Quail Brush Genco, LLC

Cogentrix Quail Brush Generation Project - Docket Number 11-AFC-3, Supplement 2 to the AFC

Data Request Responses to Set 1 for the Quail Brush Generation Project (11-AFC-3)

FIGURE 1B PROPOSED CONSTRUCTION LAYDOWN AREA

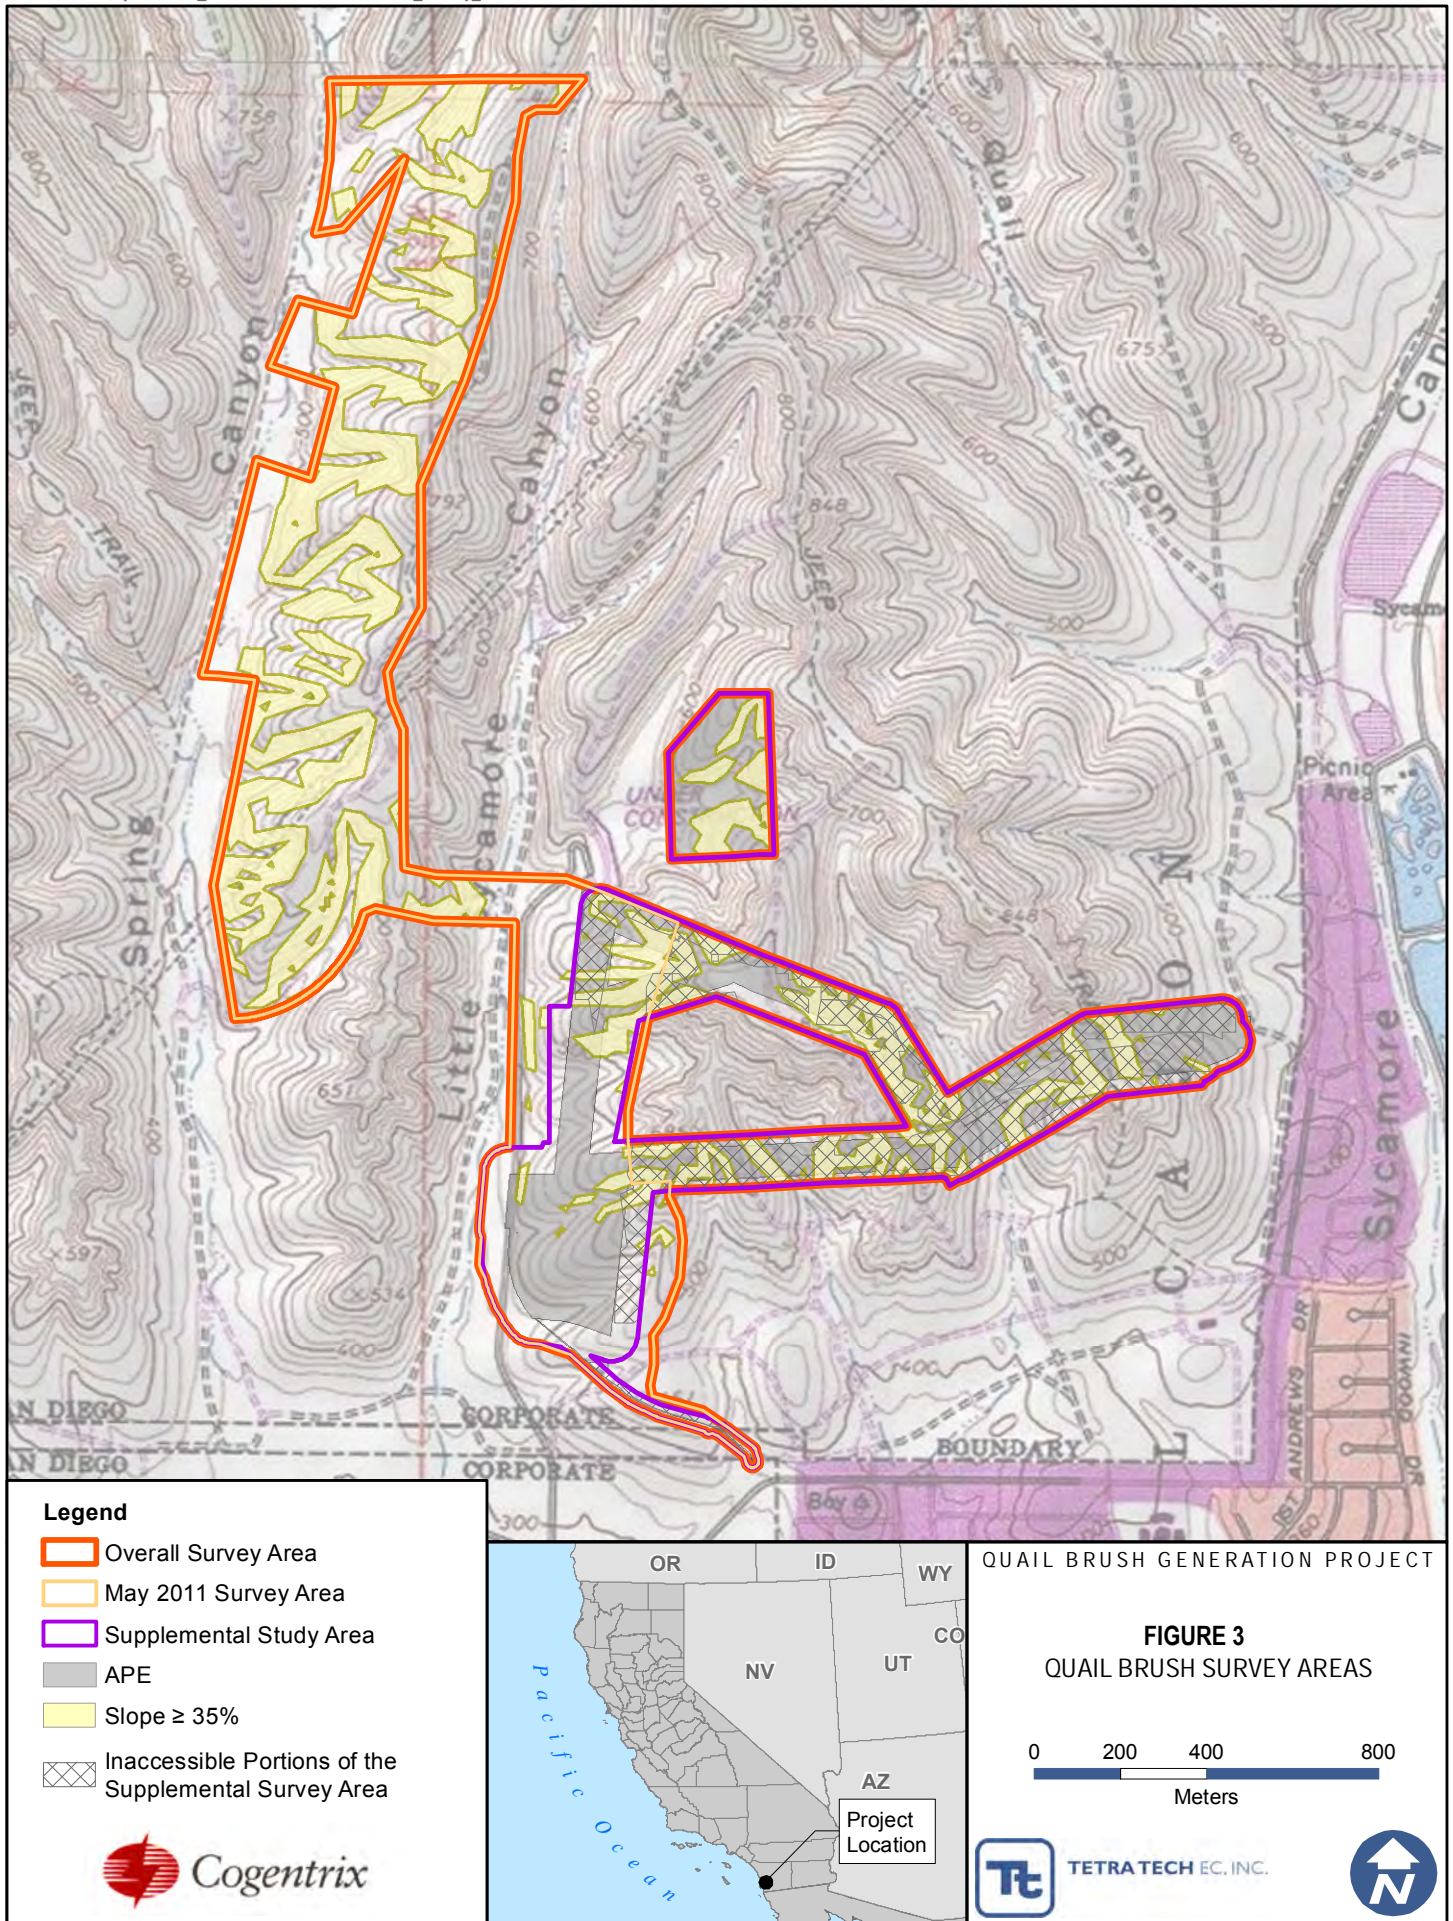
37. After finalization of the proposed location of the five-acre laydown and parking area on Sycamore Landfill property, please provide a map showing the location of this area in relation to the project site.

As stated in the 20-day letter for Data Requests 1 through 58 docketed at the CEC on February 27, 2012, and also explained in Quail Brush's Supplement 2 to the AFC docketed on February 8, 2012, Quail Brush proposes to use a yet to be identified 5-acre area within the 20-acre laydown site located approximately two-thirds of a mile north of the plant site and depicted on Figure 1.1-1 (Project Layout) of Supplement 2 (also see Figure 1B in this document). Due to the fact the 20-acre site is part of the active landfill, it will not be possible to identify the specific 5 acres that will be available and appropriate for use as a laydown and parking area until closer to the start of construction. Given the uniform nature of the 20-acre site, we do not believe that the identification of any specific 5-acre acre of the site would alter the potential environmental impacts associate with the project. Therefore, Quail Brush asks the CEC Staff to analyze Quail Brush's usage of any 5 acres within the designated 20-acre site.
